# Access Compliance Report

## Public Rights-of-Way

Intersection ID: 21826	Main Street: RENFROW_LN	Cross Street: RICHARD_BARRY_DR	Location: NW
ADA ID: C417F7BEE402	Ramp Type: Perp	Initial Pass/Fail: Fail	Overall Compliance: No
Severity Score: 37.5			
Codes/Mitigation Info/Possible Solution		Field Measurements/Component Compliance

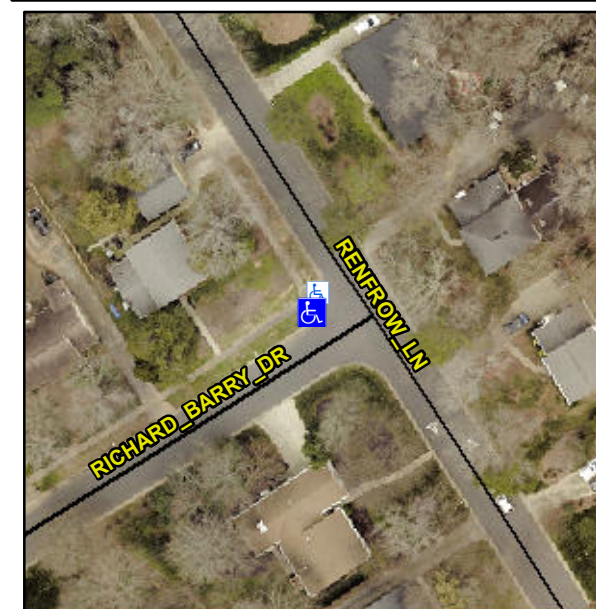
**R304.2.2, R304.5.3**

Compliance	Description	Data	Compliance	Description	Data
N/A	Ramp Length (in)	92.0	No	Ramp Slope (%)	10.9
Yes	Ramp Width (in)	48.0	No	Ramp XSlope (%)	7.4
N/A	Flare Type LT	N/A	N/A	Flare Type RT	N/A
N/A	Flare Slope LT (%)	N/A	N/A	Flare Slope RT (%)	N/A
N/A	Flare Traversable LT?	N/A	N/A	Flare Traversable RT?	N/A
N/A	Landing Length (in)	N/A	N/A	DWS Provided?	N/A
N/A	Landing Width (in)	N/A	N/A	DWS Contrast?	N/A
N/A	Landing Slope (%)	N/A	N/A	DWS Length (in)	N/A
N/A	Landing X Slope (%)	N/A	N/A	DWS Full Width?	N/A
N/A	Landing Curb? (Y/N)	N/A	N/A	DWS Offset (in)	N/A
N/A	Shared Landing?	N/A			
N/A	Gutter Ponding?	N/A	N/A	Gutter Slope (%)	N/A
N/A	Gutter Lip Ht (in)	N/A	N/A	Gutter X Slope (%)	N/A
N/A	Painted X Walk1?	No	N/A	Painted X Walk2?	N/A
	X Walk 1 Direction	To SE		X Walk 2 Direction	N/A
N/A	X Walk 1 Width (in)	N/A	N/A	X Walk 2 Width (in)	N/A
	X Walk 1 Slope (%)	0.6		X Walk 2 Slope (%)	N/A
	X Walk 1 X Slope (%)	4.3		X Walk 2 X Slope (%)	N/A

**Remove & Replace Entire Ramp.**
